80C186EA/80C188EA AND 80L186EA/80L188EA EMBEDDED MICROPROCESSORS SPECIFICATION UPDATE

Release Date: July, 1996

Order Number: 272896-001

Figure 1. Correct INT 1 Acknowledge Sequence With Higher Priority Timer Interrupt

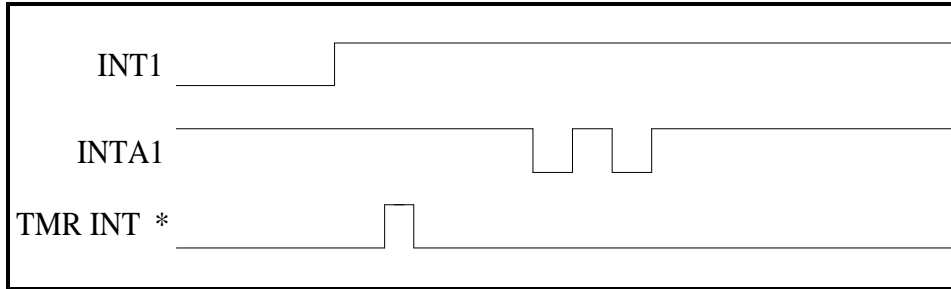
Correct operation of the device acknowledges the interrupt on INTA1# after an interrupt on INT1. Normally, this occurs even if there is a higher priority interrupt after INT1 but before the acknowledge (Figure 1).

Figure 2. Incorrect INT 1 Acknowledge Sequence With A Higher Priority Timer Interrupt

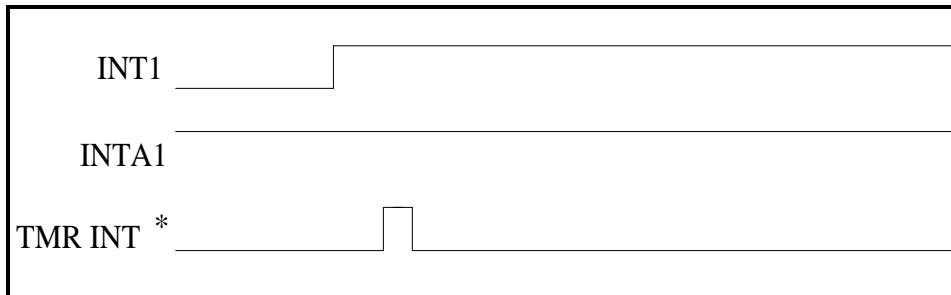
The errata occurs when a higher priority interrupt occurs between INT 1 and its expected acknowledge. The processor completes internal interrupt acknowledge cycles as seen on the status lines but no acknowledge cycle is sent on the INTA1# output (Figure 2).

Software workaround:**CONDITION**

- Use only INT 0 in cascade mode instead, or make INT 1 the least highest priority interrupt, or use hardware workaround.
- Use only one interrupt in cascade mode, or use hardware workaround.
- Make INT 0 higher priority than INT 1, or use hardware workaround.

Figure 3. INT 0 And INT 1 Acknowledge Failure Due To Higher Priority Timer Interrupt

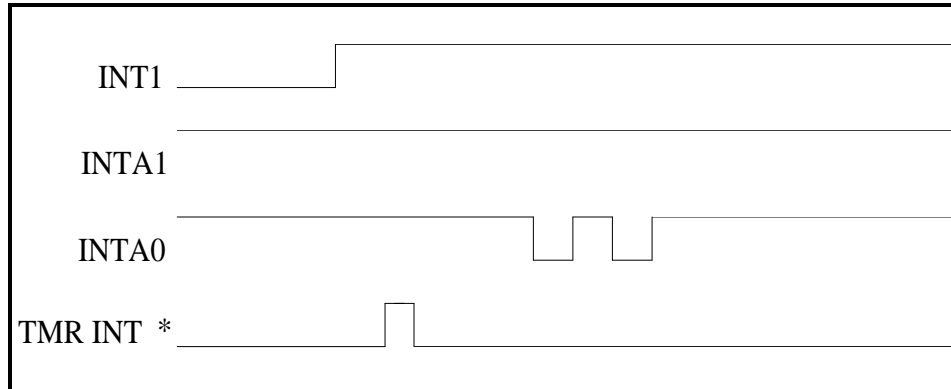
If INT 0 and INT 1 are configured in cascade mode and a higher priority interrupt occurs between INT 1 and its expected acknowledge, then the acknowledge will appear on INTA0# instead (Figure 3).

Figure 4. Correct INT 0 Acknowledge operation with a simultaneous INT 1

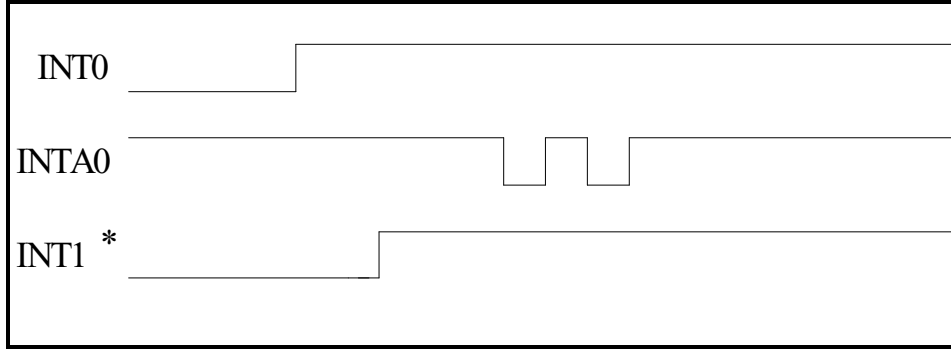
Correct operation acknowledges INT 0 on INTA0#. Normally, this occurs even if there is a higher priority INT 1 after INT 0 but before the acknowledge (Figure 4).

Figure 5. Incorrect INT 0 Acknowledge operation with a simultaneous INT 1

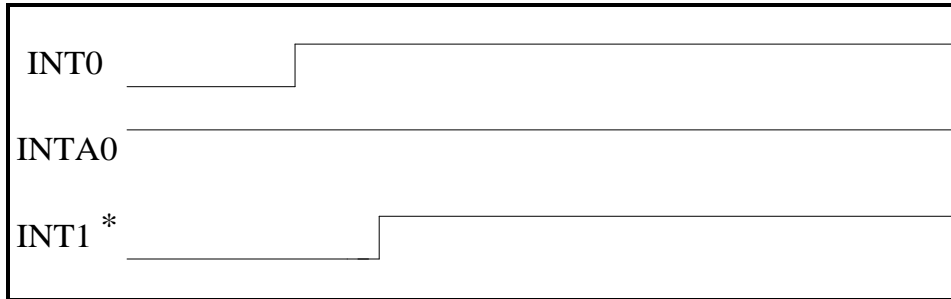
The errata occurs when INT 1, which is higher priority than INT 0, occurs between INT 0 and its expected acknowledge. The processor completes internal interrupt acknowledge cycles as seen on the status lines but no acknowledge cycle is sent on the INTA0# output (Figure 5).

Figure 6. INT 0 and INT 1 Acknowledge Failure due to the higher priority INT 1.

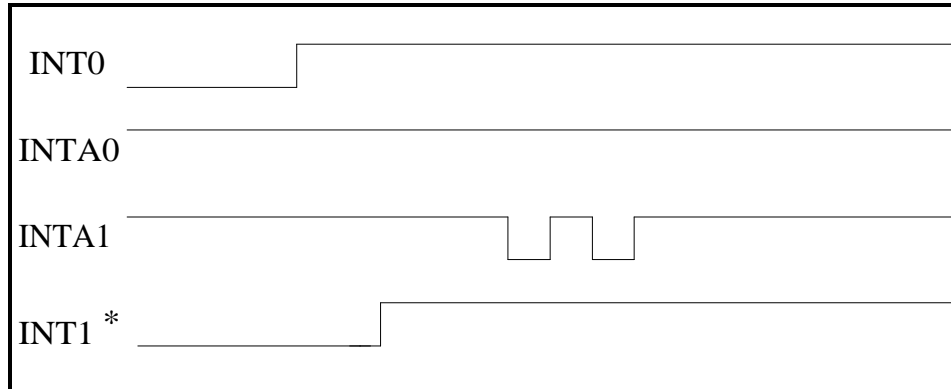
If INT 0 and INT 1 are configured in cascade mode and the higher priority INT 1 occurs between INT 0 and its expected acknowledge, then the acknowledge will appear on INTA1# instead of INTA0# (Figure 6).

Figure 7. NMI ignored during HLT entering Powerdown

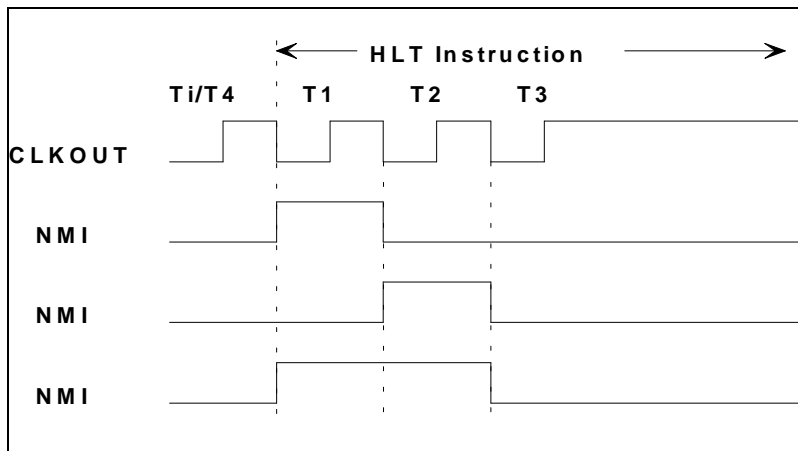
The problem occurs when an NMI occurs during execution of the HLT instruction. NMI is only serviced at valid instruction boundaries. The HLT instruction, when entering Powerdown, does not really have a boundary, it extends until Powerdown is exited. If NMI occurs between the beginning the T1 bus state and the end of the T2 state, but does not extend into T3, it will not be recognized, and the processor will enter Powerdown mode. The processor does not recognize the NMI request during the HLT instruction until the internal clock has stopped (at the end of T2).

The figures below show NMI occurring at different times during execution of the HLT instruction. Two cases are shown. Figure 7 shows cases where NMI is not recognized. Figure 8 shows cases where NMI is recognized. Both cases assume setup and hold time requirements are met for the NMI input.

If the system requires periodic NMI pulses, then the NMI pulse width must be long enough to ensure that it will extend into the T3 state of the HLT instruction. A NMI pulse width of three CLKOUT periods guarantees this.

Figure 8. NMI Recognized During HLT Entering Powerdown

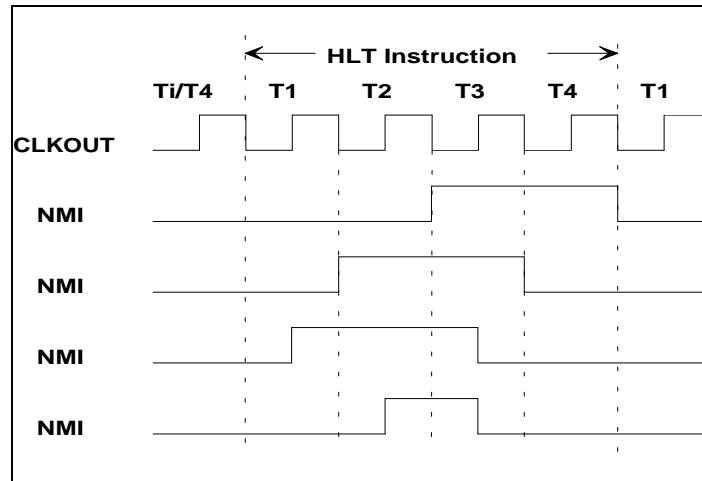
For the NMI to be recognized during the execution of the HLT instruction, the pulse must extend into T3. At this point, the processor has entered Powerdown and synchronized the NMI pulse. The NMI will be processed, but the processor will never enter Powerdown. Essentially, because NMI is active, the processor exits Powerdown as soon as it enters.
